AMENDMENTS TO THE DRAWINGS:

REMARKS

This communication is a full and timely response to the non-final Office Action dated October 26, 2005 (Paper No./Mail Date 10182005). By this communication, the specification and Figure 1 of the drawings have been amended.

Fig. 1

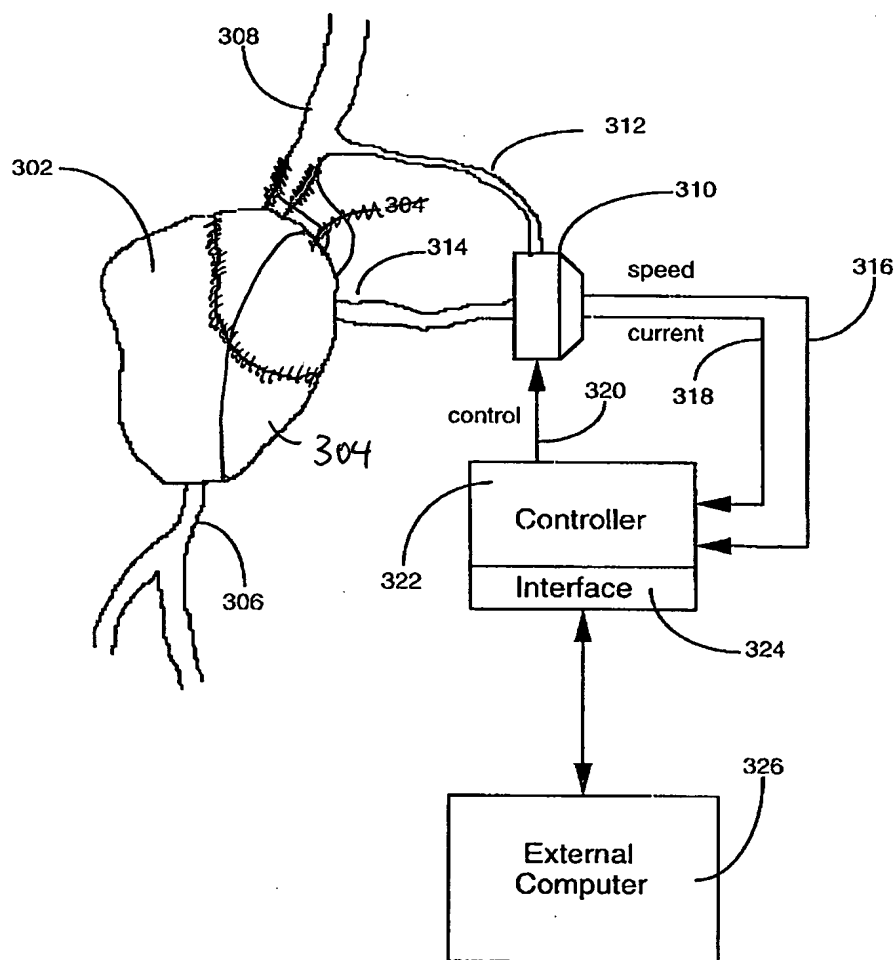
In the replacement sheet, Figure 1 has been amended to change the location of the element number 304, as shown. Moreover, the figure component identified by element 310 has been labeled "pump", as shown.

Figure 1 has been amended to change the location of the left ventricle identified by element number 304, and to label the figure component identified by element 310 a "pump". Support for the changes to Figure 1 can be found variously throughout the specification, for example, in paragraph [0012]. No new matter has been added.

The drawings were objected to for allegedly failing to properly identify the anatomical location of the left ventricle designated by element 304 and allegedly not properly labeling the figure component designated by element 310 as a "pump". Applicant respectfully traverses these objections. However, in an effort to expedite prosecution Applicant has attached both an annotated and a replacement drawing sheet that remedy the alleged deficiencies. Accordingly, Applicant respectfully requests that the objection of Figure 1 be withdrawn.
